The following changes / clarifications in the tender documents are effective immediately. This Addendum will form part of the Contract Documents.

Glacier National Park – Rogers Pass Maintenance Compound –

Water Source Conversion

Rogers Pass, BC

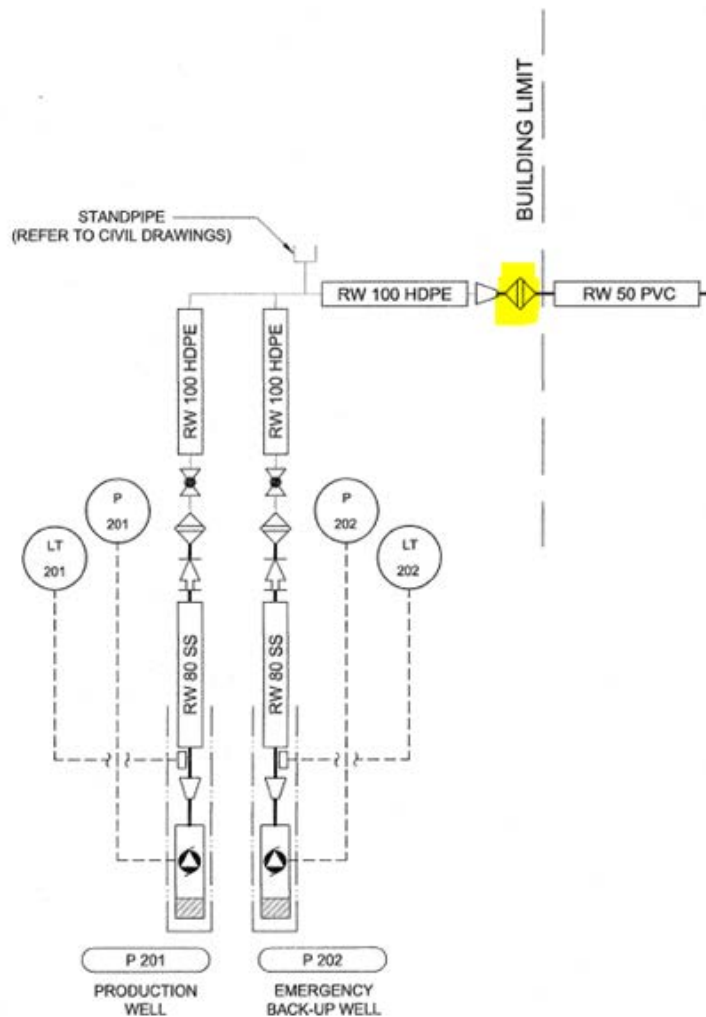
- Existing Water Treatment System on Sheet P03 is adapted from UMA Piping & Instrumentation Diagram. Project #77146, Drawing Reference No. G95R1, Sheet No. P1.
- Section 2 on Drawing M101 – below is a supplemental sketch of the tie-in point to existing piping, supplied for information purposes:
